TRANS/WP.29/733

World Forum for Harmonization of Vehicle Regulations (WP.29)

DRAFT SUPPLEMENT 3 TO REGULATION No. 91

(Side-marker lamps)

Annex 3, Example 1 (a) ,amend to read:

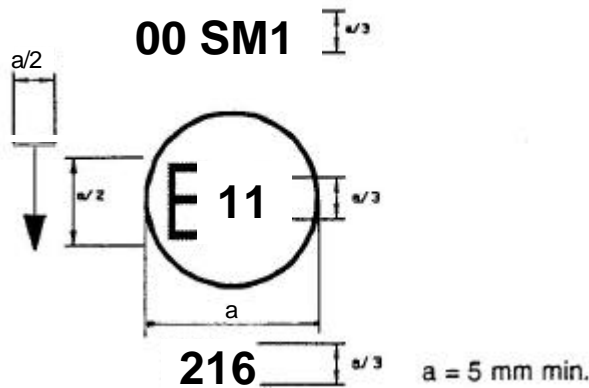
Annex 3, add a new sentence at the end of the caption below the figure, to read:

".... number 216. The vertical arrow starting from a horizontal segment and directed downwards indicates a permissible mounting height of equal to or less than 750 mm from the ground for this device.
